Project Description: Riverview Villas

Project/File: Riverview Villas / GCPP25-0001 / SUBFY2025-0001

This is a preliminary plat and planned unit development application to allow for the development of a 14-lot subdivision, consisting of 12 single-family attached residential lots and 2 live/work lots on .7 acres.

Staff Approval: January 28th, 2025

PRELIMINARY PLAT SHOWING
RIVERVIEW VILLAS SUBDIVISION

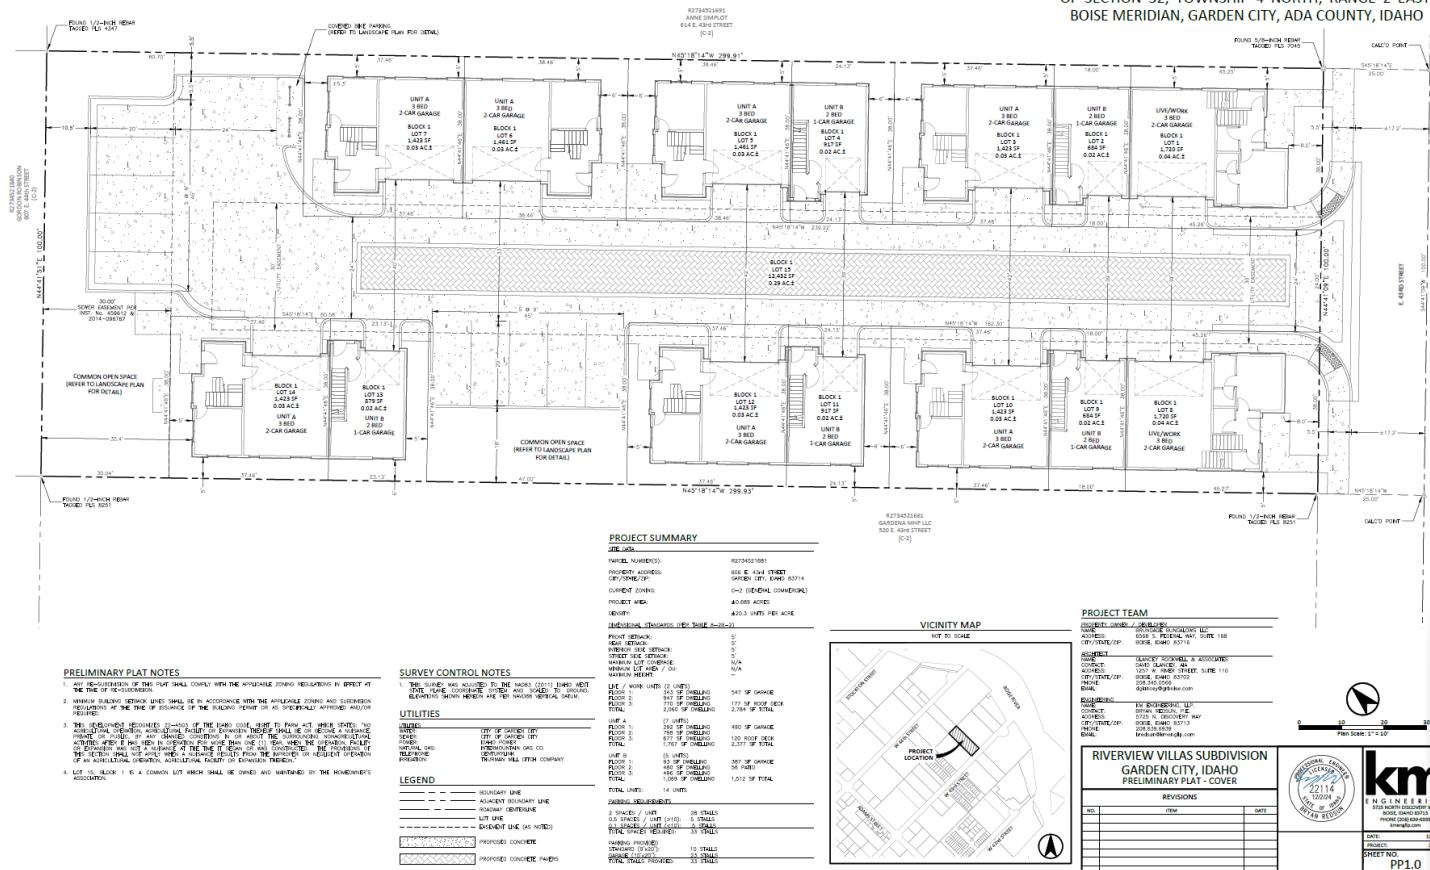
2. Close the existing 37-foot wide curb cut type driveway from the site onto 43rd Street, located 1,099-feet north of Adams Street, with curb, gutter and sidewalk.

3. Construct a 24-foot wide paved, curb return type driveway from the site onto 43rd Street located 1,073-feet north of Adams Street.
4. Submit civil plans to ACHD Development Services for review and approval. The impact fee assessment will not be released until the civil plans are approved by ACHD.

- a. Existing Conditions:** There is an existing 37-foot wide curb cut type driveway from the site onto 43rd Street, located 1,099-feet north of Adams Street.
- b. Applicant's Proposal:** The applicant is proposing to close the existing driveway with curb, gutter and sidewalk.

The applicant is proposing to construct a 24-foot wide paved, curb return type driveway from the site onto 43rd Street, located 1,073-feet north of Adams Street.

- c. Staff Comments/Recommendations:** The applicant's proposal meets District policy and should be approved, as proposed.
